TIPS FOR PREVENTING EXPENSIVE WARRANTY CLAIMS

National Home Warranty would like to bring the following issues to your attention with the intention of assisting you in avoiding costly claims. As you are aware, water ingress through a building envelope is a 5-year warrantable item. Keeping that in mind, we have detailed a number of envelope and other construction errors that we have witnessed during inspections and would like to bring them to your attention.

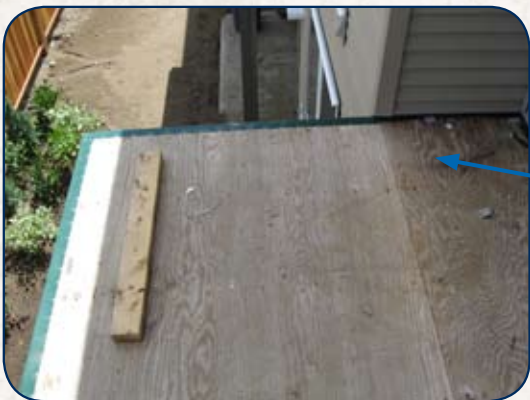
Building paper should overlap the deck membrane.

The metal strip placed into deck to wall connections is unnecessary and the screws puncture the vinyl membrane allowing a potential leak every few inches.

Good deck side to wall connection.

The vinyl membrane should wrap up and into the rough opening of the door sill. The door sill then sealed to the membrane. As decks are now roofs under the BC Building Code therefore the vinyl membrane should run up the wall a minimum of 6" behind the cladding and under the wall paper. The door sill should be 6" above finished deck / patio heights. This requires lowering the deck or raising the door. We allow a relaxation of this to 3" - 4" for roofed over decks and entrances. A 2' overhang is not considered roofed over.

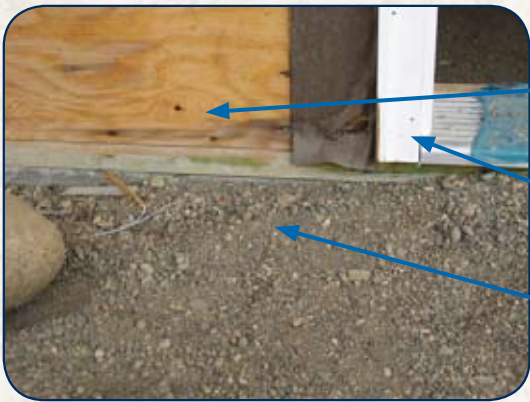
Using a starter strip or a perforated j-bead is required at the bottom of a vinyl wall.

Here a non-perforated j-bead causes water leaking from a hose bib to carry horizontally to the right and put water into a door sill opening.

Vinyl siding must be kept 2" from the finished roofing.
